**PLANNED UNIT DEVELOPMENT
& SUBDIVISION STAFF REPORT****Date: November 5, 2009****DEVELOPMENT NAME**

Grady Buick Company, Inc.

Grady Automotive Subdivision

LOCATION3025 Government Boulevard
(Southeast corner of U.S. Highway 90 and McVay Drive North)**CITY COUNCIL
DISTRICT**

SUBDIVISION DETAIL

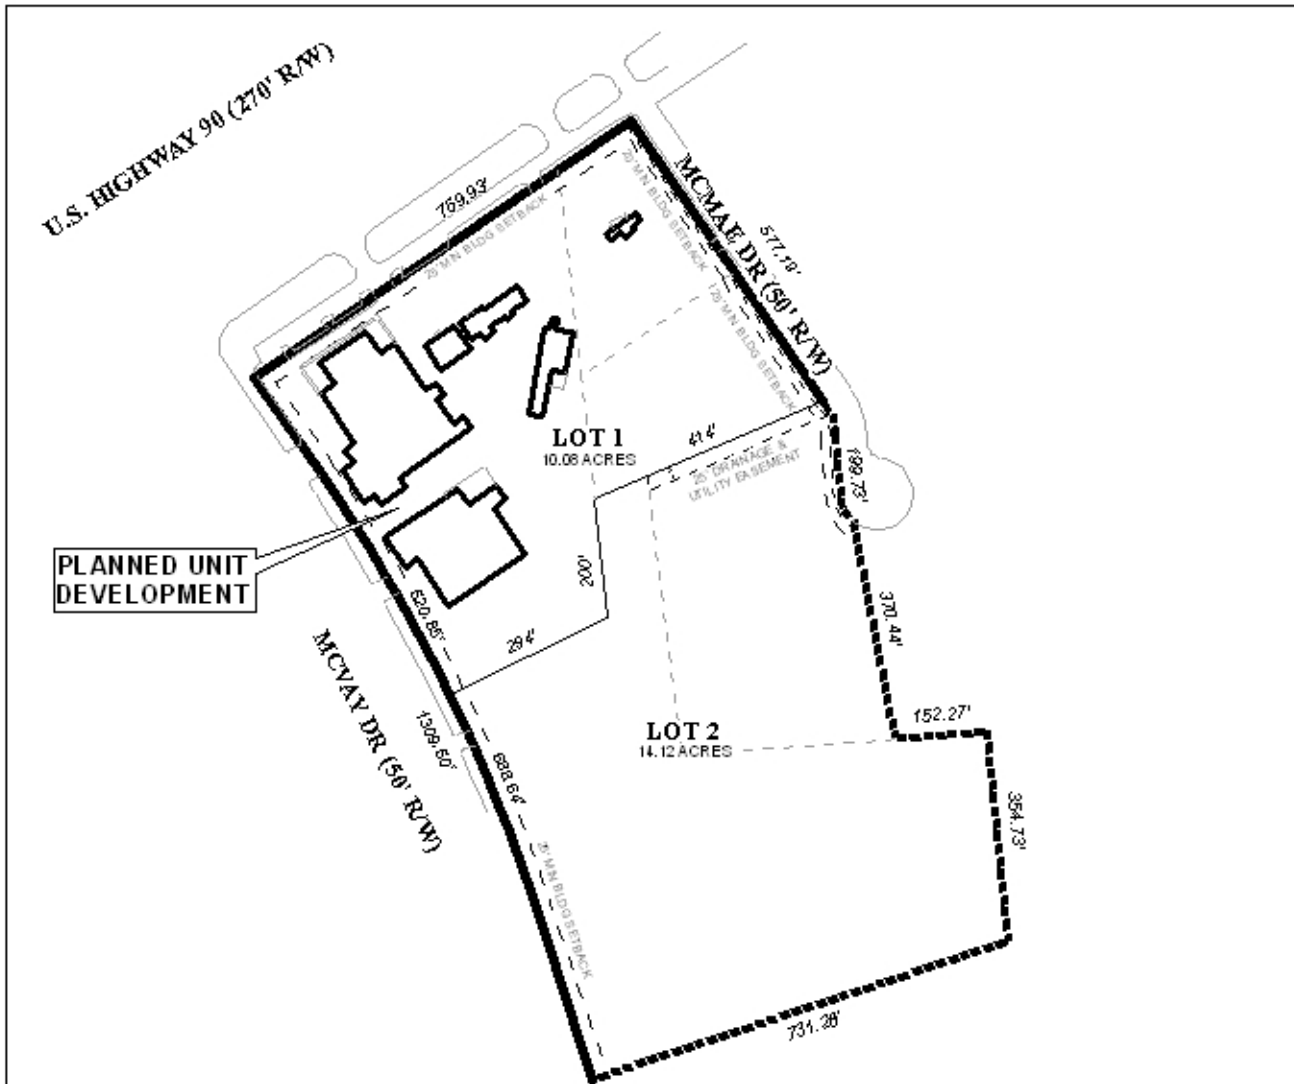
As proposed, Lot 1 has approximately 760' of frontage along Government Boulevard Service Road, with 620' and 577' of frontage along MacVay and Macmae Drives respectively; Lot 2 has approximately 689' and 209' of frontage along MacVay and Macmae Drives respectively. As a means of access management, curb cutting for Lot 1 should be limited to an approved PUD site plan; Lot 2 should be limited to two curb cuts to MacVay Drive and one curb cut to Macmae Drive.

As proposed, the plat does not illustrate adequate radii where Government Boulevard Service Road intersects both MacVay and Macmae Drives. The applicant should revise the plat to comply with Section V.B.16 of the Subdivision Regulations.

- 1) provision of adequate radii where Government Boulevard Service Road intersects both MacVay and Macmae Drives, as required by Section V.B.16 of the Subdivision Regulations;

SITE PLAN

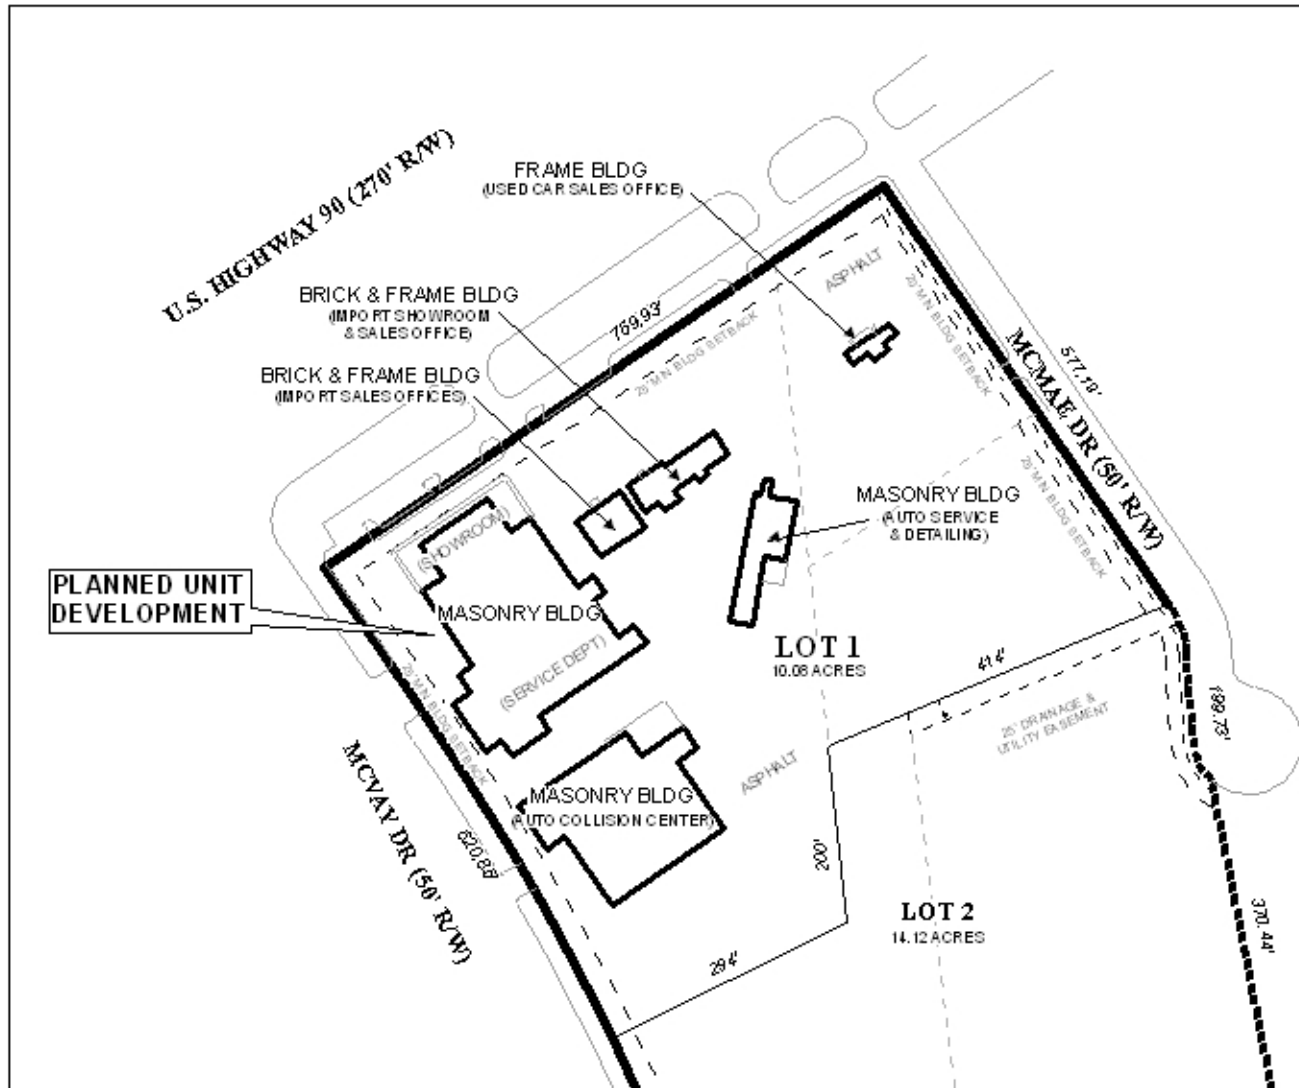
It should be noted that Planned Unit Development application is for Lot 1 only, which contains an existing automotive dealership. The site plan illustrates all existing buildings on-site; however, it does not contain any information regarding parking, landscaping, dumpster location, etc. While it isn't necessary for *approval*, since no construction is proposed, an as-built site plan containing all pertinent information should certainly be submitted to the Planning Section of Urban Development, so that it may serve as the official PUD site plan on file. This should be done prior to signing the final plat.

- 2) submission of a revised PUD site plan illustrating all pertinent information regarding parking, landscaping, dumpster location, etc;
- 3) placement of a note on the site plan stating that the site must be developed in compliance with all local, state and Federal regulations regarding endangered, threatened or otherwise protected species;
